“Level crossing” signs proposals analysis

“Level crossings”-signs study: Introduction

Having analysed information provided by the UN’s Level Crossings Group (LX) on proposed new signs to substitute A25 and A26a, and the introduction of a “Break Gate” sign,

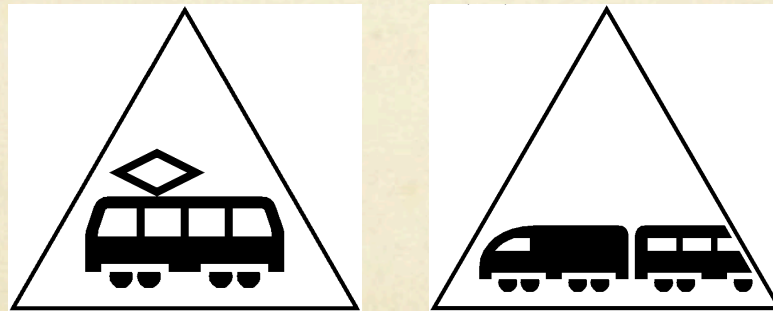
3 Emphasize the danger coming from one side

To do so, the train needs to be shown from the side.

Yet, if a modern train model is chosen,

- confusion with symbols such as “Tram”, “Bus” or “Truck” has to be avoided. Therefore the (modern) train would become a lengthy construct that resembles a thick horizontal line, not efficiently using given space.

This does not support visual discrimination of a symbol, nor understanding as it could.

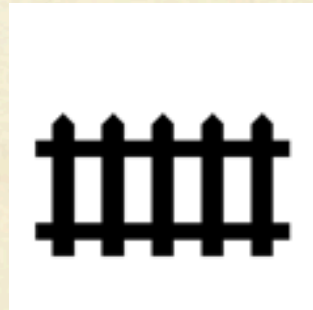
Instead of A25 and A26b only, the “Break Gate” sign is to be into account as well for choice of symbols -

- as components of symbols in these three signs need to correspond, in order to support sign comprehension:

- “Steam train” (in A26a & possibly as envisioned for A25)
- “Gate” (,new model, in A25 and in “Break Gate” sign)
- “Passenger car” (showing the rear), as seen in road signs such as A8, A9, A24, C23 etc.

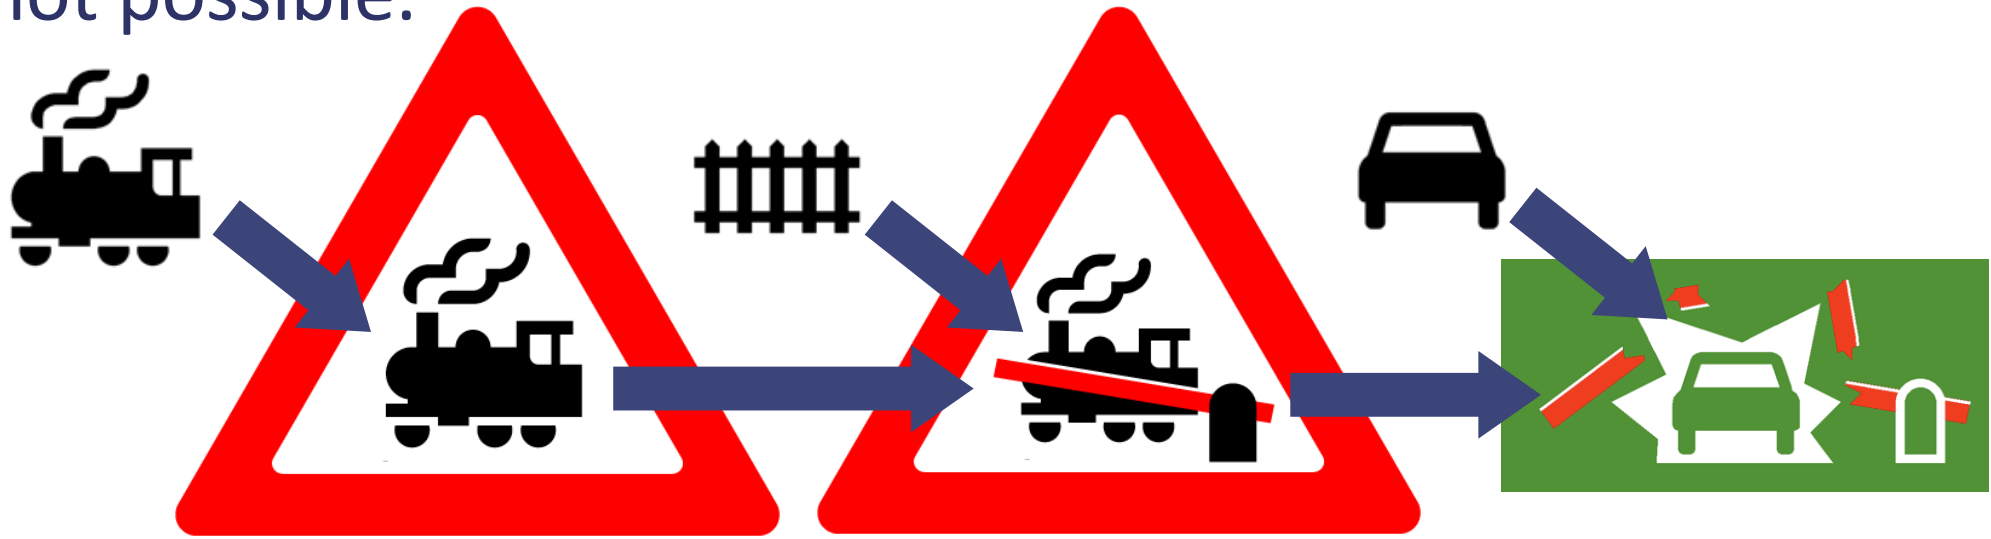
If component “steam train” in A26a is not identically used in A25, A25’s envisioned improvement of comprehensibility is not possible.

If component “new gate” is not used in sign A25 and “Break gate”, the opportunity to support drivers’ comprehension is lost.
